**ADDENDUM NO. 2- QUESTIONS AND ANSWERS CONTINUED
IFB-GC-FG-01-24
FAIRGROUNDS RESTROOM**

Garfield County
GARFIELD COUNTY FAIRGROUNDS
RIFLE, COLORADO

NEW RESTROOM
PLUMBING ISOMETRIC

1 PLUMBING ISOMETRIC
P101 SCALE: 3/8" = 1'-0"
WHEN PLOTTED @ 24" x 36"

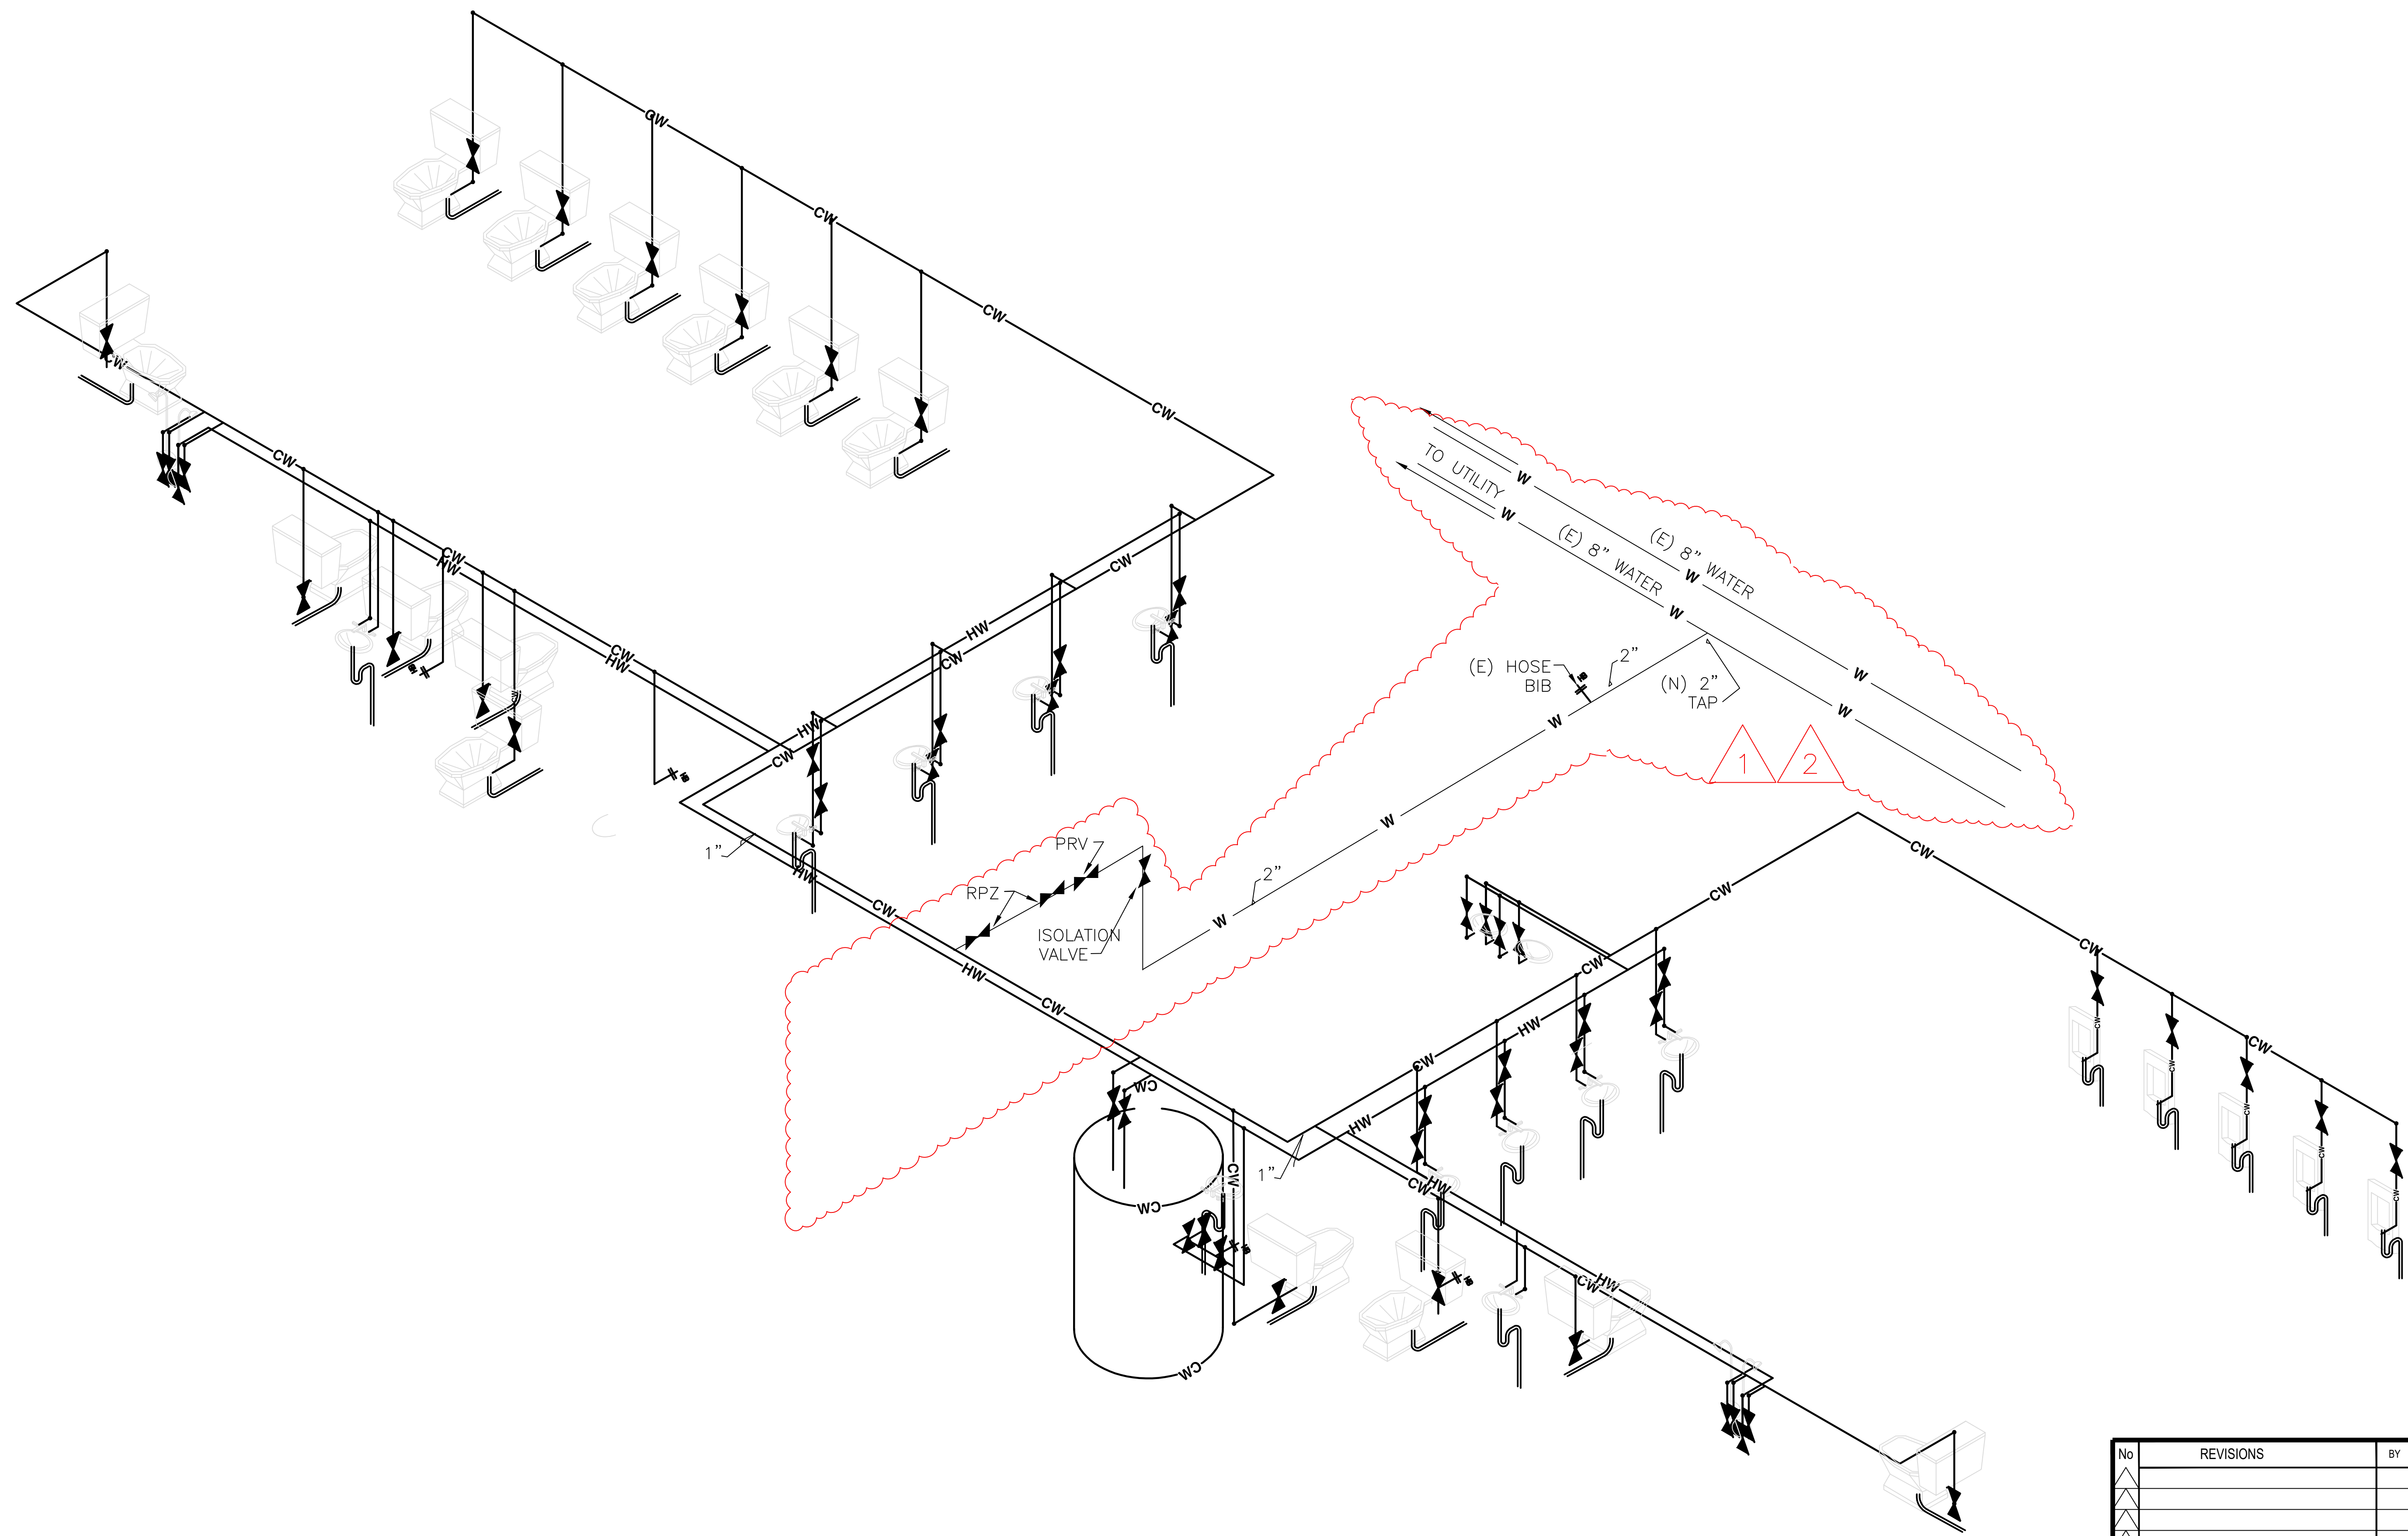
Question 1: Our plumbers have come back inquiring about the 1-inch water service to the building, and that it will not provide enough water for the number/type of fixtures. Please take a look at this issue. The 1" service is marginal for the number of fixtures involved, but the length of the service is only about 5 feet away from an existing 8" water line, plus the length of the lines inside the building are fairly short, so pressure losses would be minimal. To be overly conservative, we have increased the service to 2", and show the new tap into the existing 8" line. The isolation valve, pressure reducing valve, and reduced pressure zone assembly are also upsized to 2" diameter, as shown on the attached updated P101 drawing.
